CITY OF KELOWNA
MEMORANDUM

DATE: May 15, 2008
TO: City Manager
FROM: Planning & Development Services Department
APPLICATION NO. OCP07-0019, Z07-0067 **APPLICANTS:** Roland Nadon

AT: 695 Webster Road **OWNER:** 0754290 B.C. Ltd.

PURPOSE: TO AMEND THE OFFICIAL COMMUNITY PLAN DESIGNATION OF
THE SUBJECT PROPERTY FROM SINGLE/TWO UNIT RESIDENTIAL
TO MULTIPLE UNIT RESIDENTIAL - LOW DENSITY

REVISED ELEVATION – DP6a

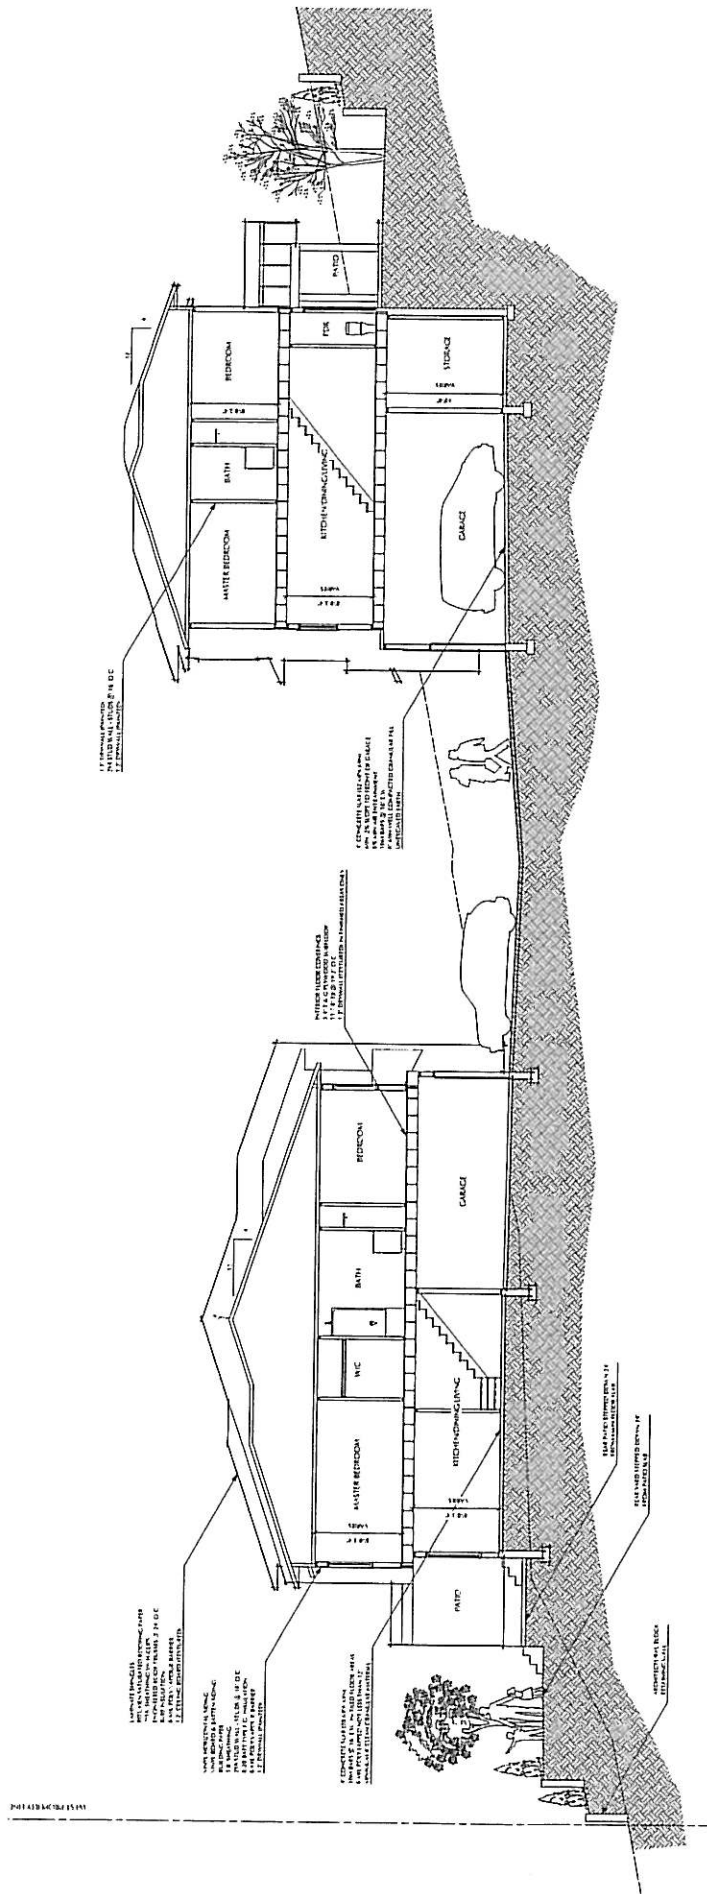
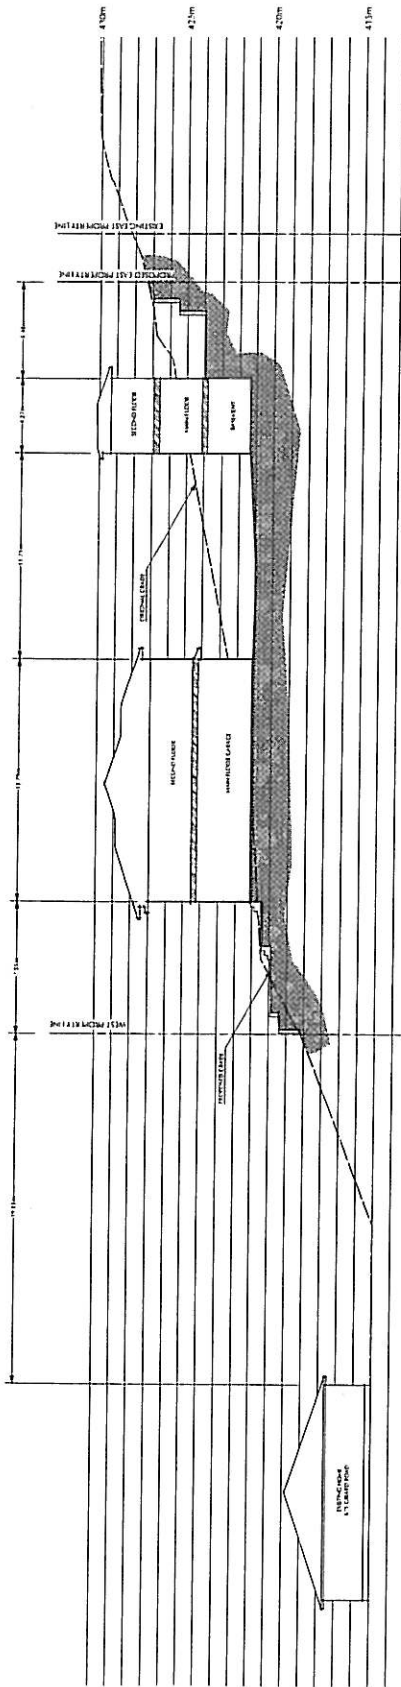
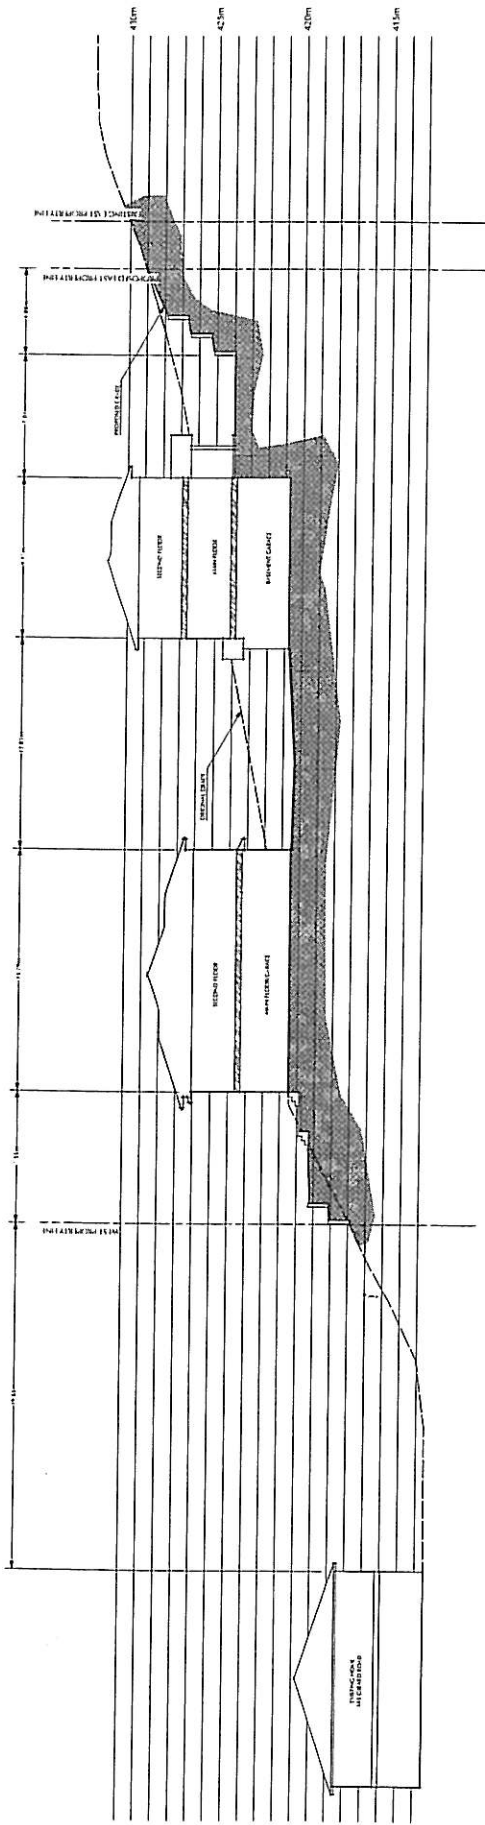
REVISED ELEVATION – REFER TO DP6a ATTACHED

RETAINING WALL LAYOUT

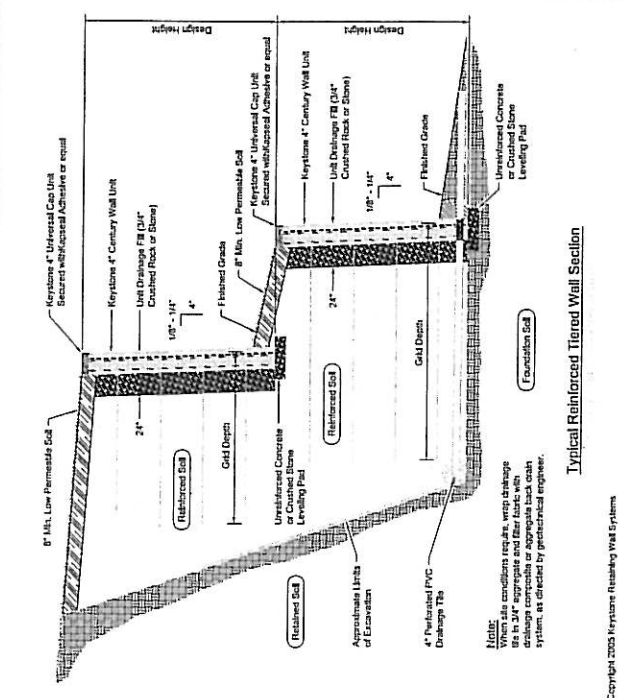
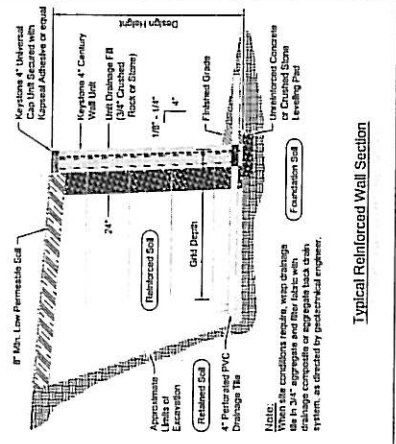
^B The applicant is requesting a variance to the height of proposed retaining walls as shown on the "Site Grading & Retaining Wall Layout" Plan (Sheet No. G-1 & G-2) Prepared by Site360 and dated May 15, 2008.

The variance to the height of the retaining walls proposed along the eastern property line as indicated on the Site360 site Grading & Retaining Wall Layout Plan will be internal to the site and will not be seen from Webster Road. The proposed landscaping is expected to soften the impact of the walls along the eastern property line. The retaining wall at the south property line is also internal to the site however; it will be more exposed to the residents as it is a single wall with limited landscaping to hide it.
